RE: Comments To The Revised Draft Supplemental Environmental Impact Statement,
Pinedale Anticline Oil and Gas Exploration and Development Project, Sublette County,
Wyoming

**BP Comments on the Air Quality Impact Analysis Technical Support Document
For the Revised Supplemental Environmental Impact Statement
For the Pinedale Anticline Oil and Gas Exploration Project**

Figure 6. Change in Visual Range by Methodology

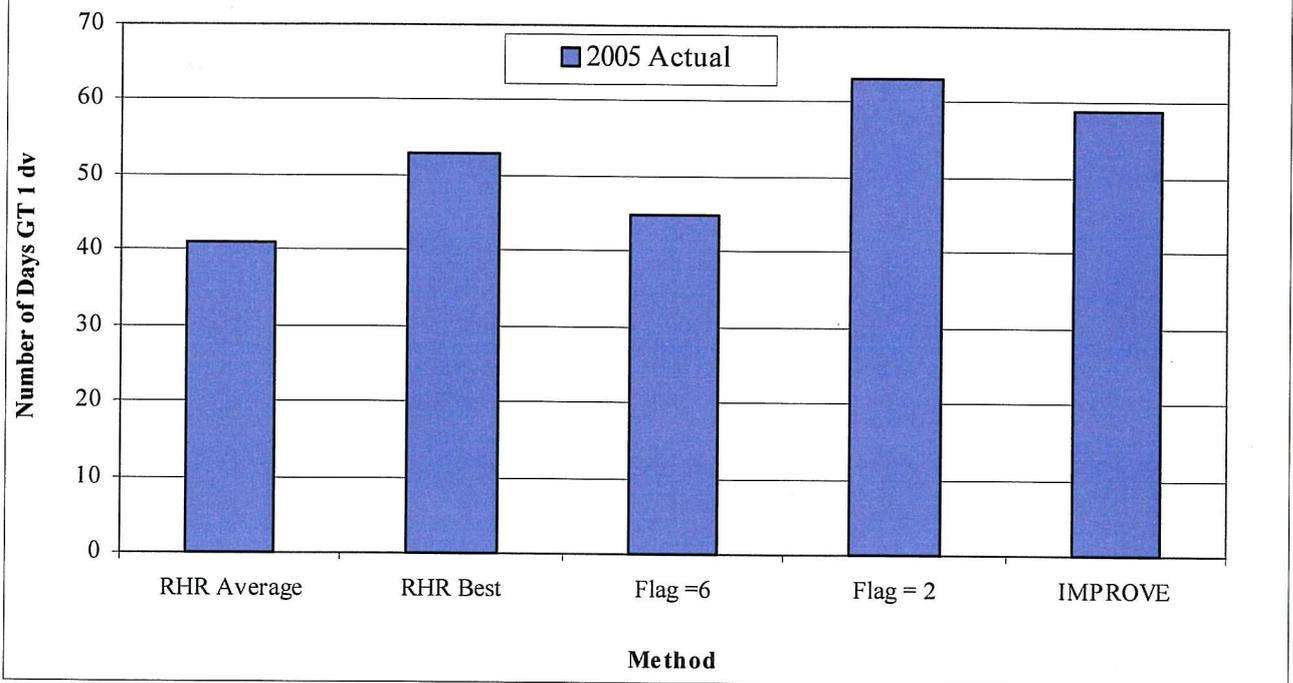
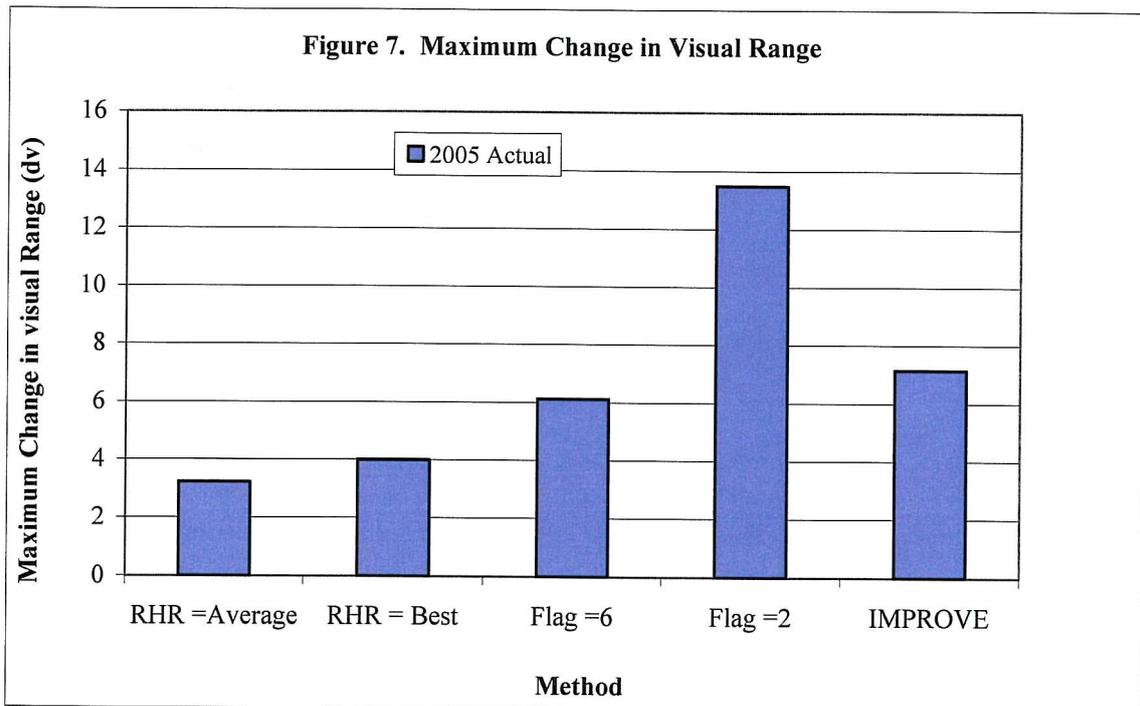
In the TSD, BLM presents five different calculation methods for converting concentrations of fine particulate into changes in visual range. Figures 6 and 7 present the number of days greater than 1 dv and the maximum change in visibility using the five calculation procedures for the 2005 actual case. In these figures the underlying modeling is constant (i.e., the modeled concentration estimates are unchanged). Comparing these methods indicates that there are substantial differences in the perceived change in visibility depending on what calculation method is used. For example, the number of days in excess of 1 dv increases from 40 to 62 in the 2005 actual emission inventory case if the BART calculation procedures are used versus Method 2 that assumes hourly concentration estimates. Similarly, the maximum change in visual range increases from 3 dv (using the RHR and average background concentrations) to almost 14 dv (using Method 2). This perceived change in visibility is simply a function of different calculation methods. It is important to keep in mind that this information is for 2005 actual conditions and such projections are inconsistent with the monitoring data. It is recommended that BLM adopt the RHR using average conditions. There is a technical basis for this selection as all of the other calculation procedures assume very clean background conditions (IMPROVE cleanest 20% days or FLAG default) for every day of the year, an unrealistic assumption. Maximum visibility impacts are based on the maximum modeling impacts that occur under worst case meteorological impacts and assuming that they coincide with the days having the best visual range is counter intuitive. In addition, the RHR using average air quality is consistent with the methodology that is being used by EPA and the States to determine if a source is exempt from performing a BART analysis. The other suggested calculation procedures have no regulatory basis.

It is also recommended that BLM adopt the revised IMPROVE calculation procedures that were established in 2006.

Figure 8. Just Noticeable Change Surface Plotted as a Function of Observer Distance and Atmospheric Extinction.⁵

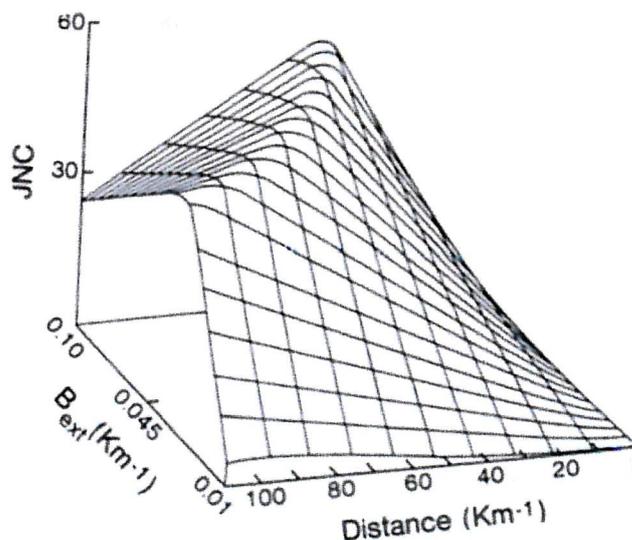
The NAPAP reference raises several important questions regarding the JNC threshold over long sight paths. First, there is no clear definition of what the statement “a change in extinction coefficient of approximately 5% will evoke a just noticeable change **in most landscapes**” means. Second, it is also unclear how universally applicable this threshold could be over a large range of sight paths. Figure 8 presents a plot of the JNC threshold as a function of sight path and indicates that the JNC threshold is dependant on the sight path³. This suggests that the establishment of a human perceivable JNC threshold may be dependant on the longest sight path within a Class I Area and that the establishment of a single JNC threshold might not be appropriate and therefore contrary to what EPA has proposed.

presume that a fractional change in extinction coefficient between 5 and 20 % would produce a JNC in a scene⁶. The use of what appears to be a **presumptive** sensitivity analysis to develop a JNC threshold is not appropriate. The authors also conclude “a 1 to 2 dv change corresponds to a small visibility perceptible change in a scene appearance **where the assumptions used in developing the deciview scale are met.**”⁷ This would translate to a change of 10 to 20 percent in extinction. Because a 1 to 2 deciview change is perceivable only if the assumptions used to develop the deciview scale are met, it is important to review the assumptions that were made in the development of the deciview

Figure 9. Comparison of Lengths of the Longest Lines for 35 National Parks and the Estimated Sight Path Within These Parks¹¹

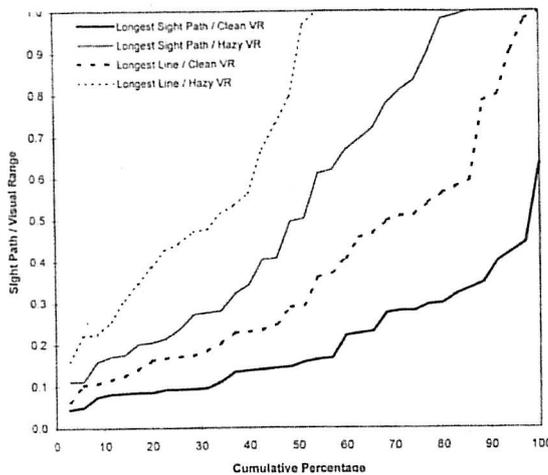
It is important to place the assumptions used by Pitchford and Malm into practical perspective. Figure 9 presents a comparison of the longest lines that can be drawn within 35 Class I Areas as well as the estimated lengths of the longest visual range sight paths within these areas¹⁰. The visual ranges were calculated from the average light extinction coefficient for the 20 percent of the days that were the least impaired (clean) as well as the 20 percent of the days that were the most impaired (hazy). A point on a line indicates the percentage of the parks that have a ratio equal to or smaller than the value at that point. Most ratios are less than 1 and therefore sight paths are typically shorter than the visual range and contrary to the assumptions used in the development of the deciview index. This indicates that for a vast number of Class I Areas, the basic assumption of the deciview calculation has not been met. Thus, assuming that the sight path is equal to the visual range simply adds a layer of unnecessary additional conservatism to the calculation.
